**PRELIMINARY/FINAL DRAINAGE REPORT
FOR
REDTAIL RANCH FILING 1**

**ADDENDUM NO. 1
APRIL 2020**

PCD Project No. SP-18-004/SF-18-021

**PRELIMINARY/FINAL DRAINAGE REPORT FOR
REDTAIL RANCH FILING NO. 1 (Addendum No. 1)**

RETAIL RANCH FILING NO. 1
PRELIMINARY/FINAL DRAINAGE REPORT
DEVELOPED DRAINAGE MAP

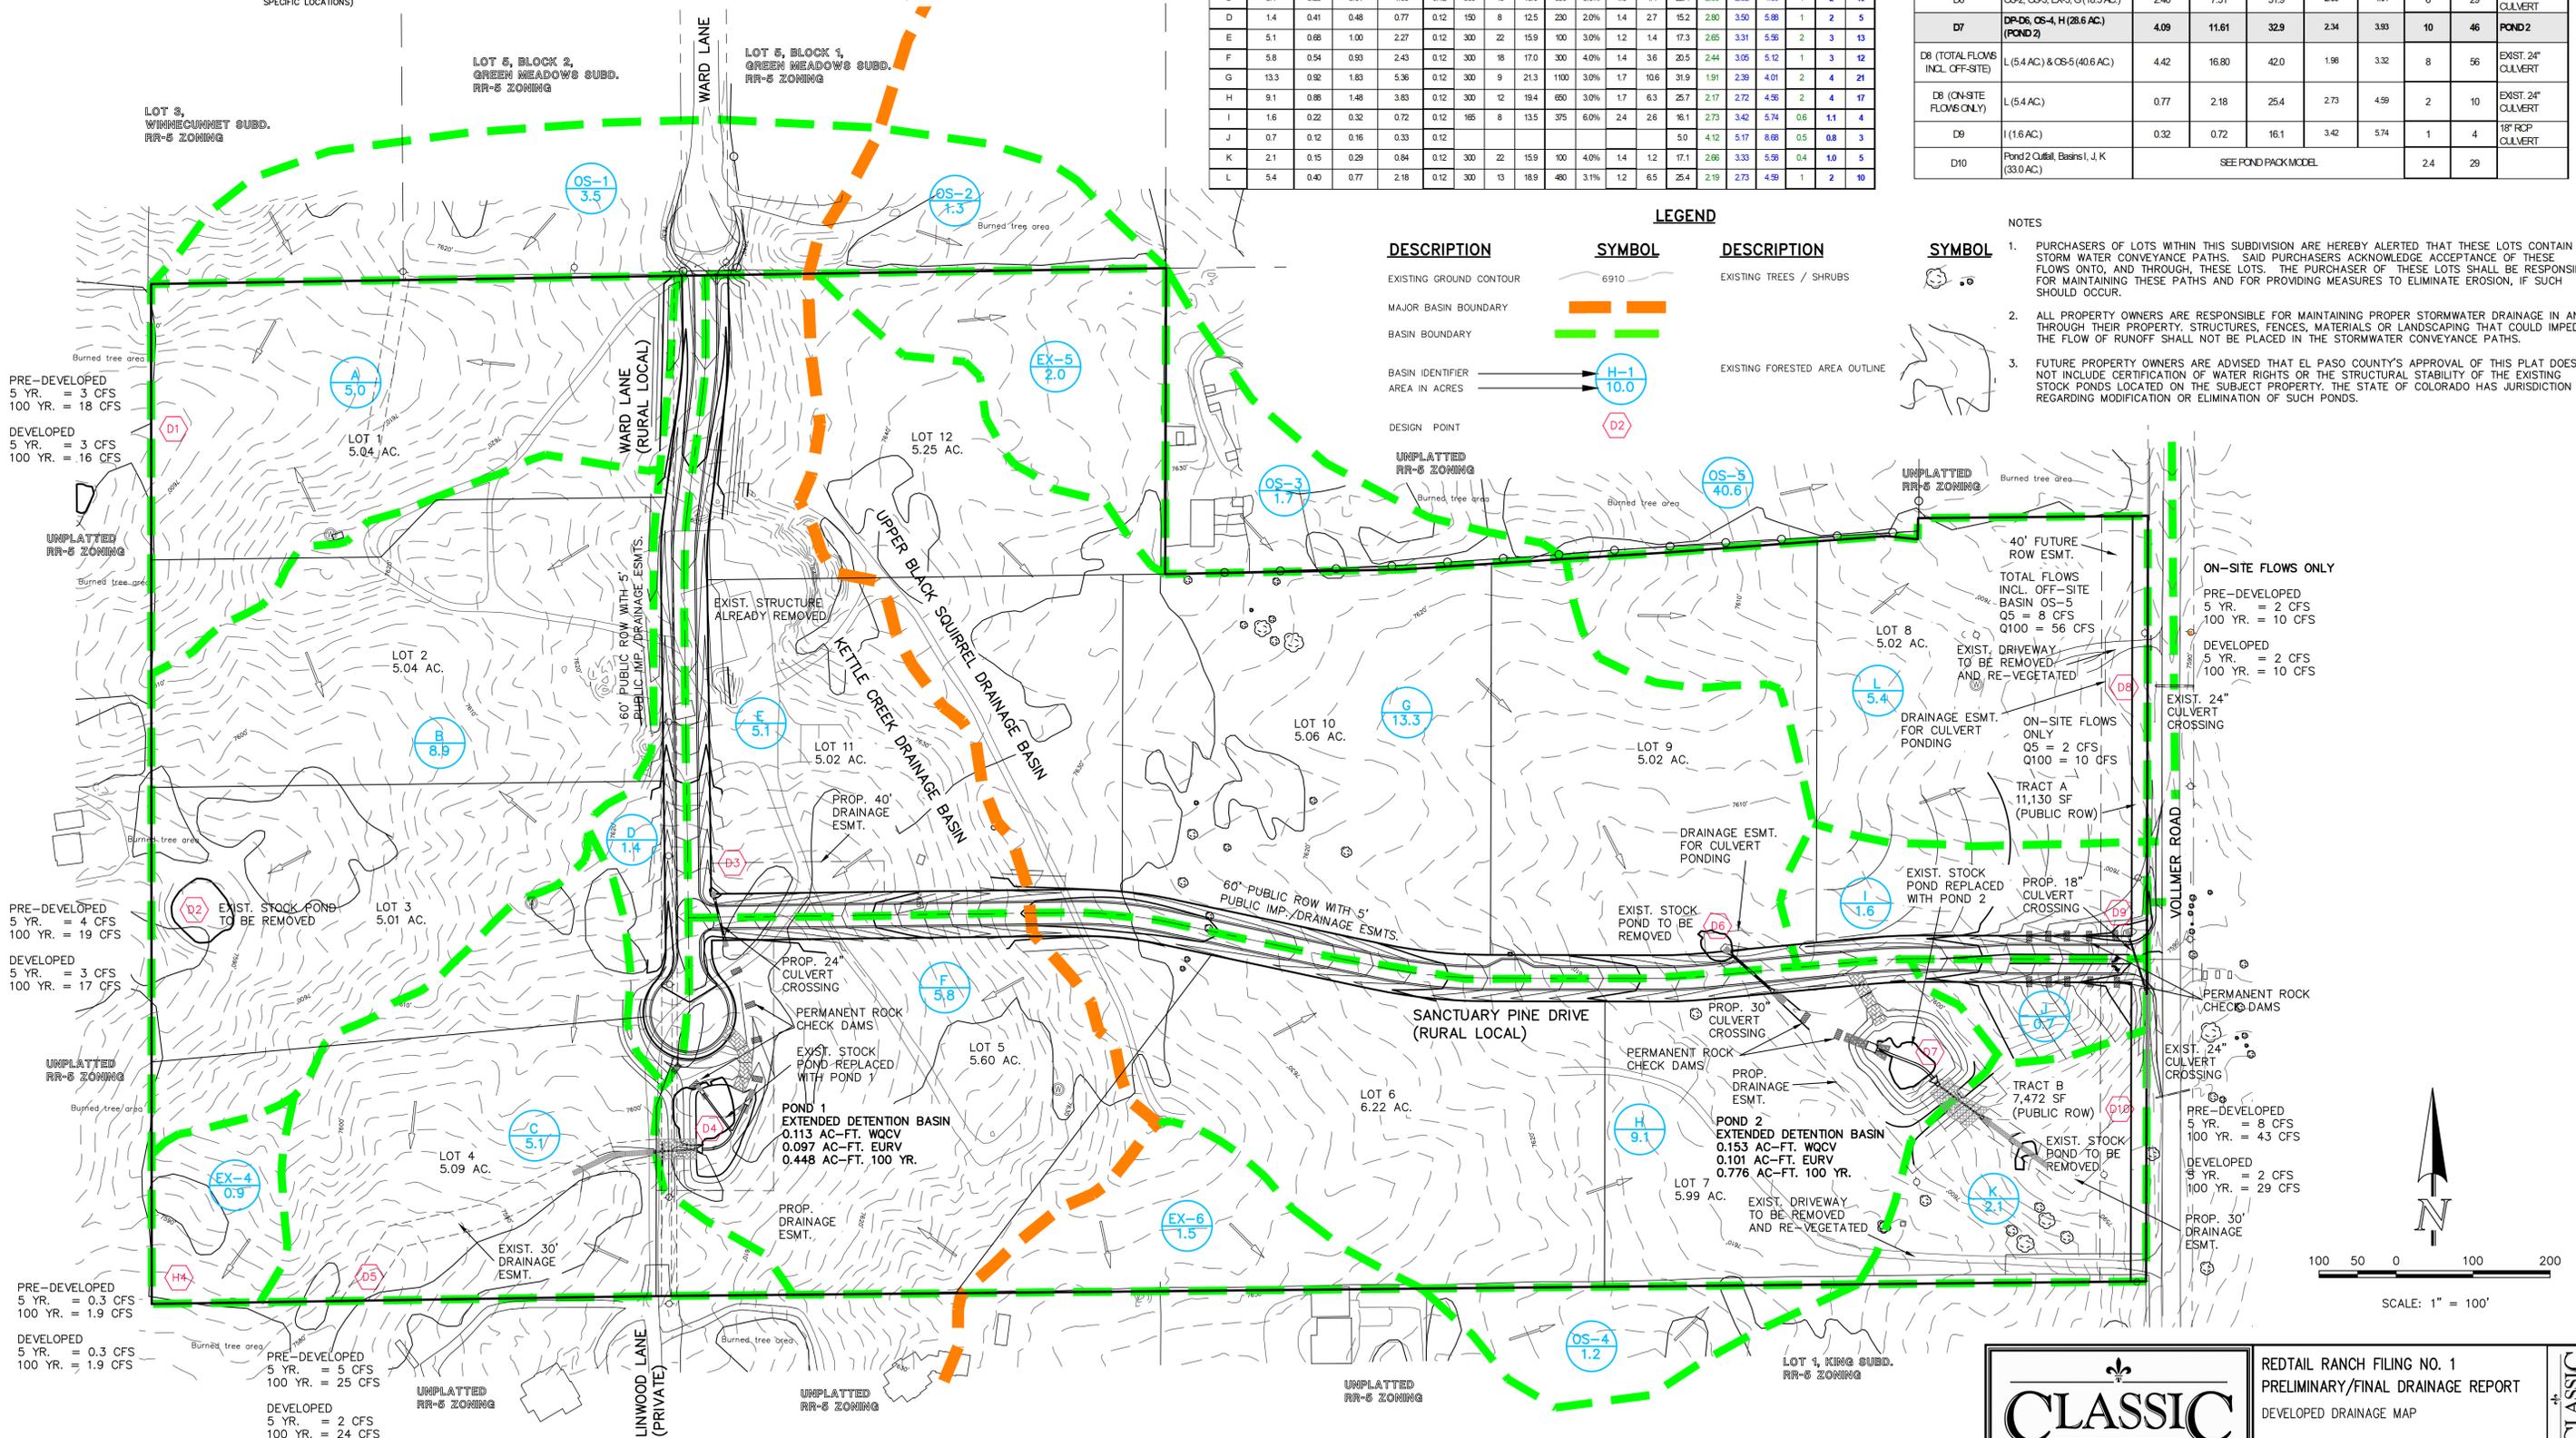
This document is Addendum No. 1 of Preliminary/Final Drainage Report for Redtail Ranch Filing No. 1. The purpose of this addendum is to revise the two stormwater quality facilities from Sand Filter Basins to Extended Detention Basins. All hydrology, pond sizing and locations remain the same as previously approved. (Reference Preliminary/Final Drainage Report Redtail Ranch Filing No. 1)

Pond 1 (Extended Detention Basin) has the following design parameters as a full-spectrum facility:

Pond 2 (Extended Detention Basin) has the following design parameters as a full-spectrum facility:
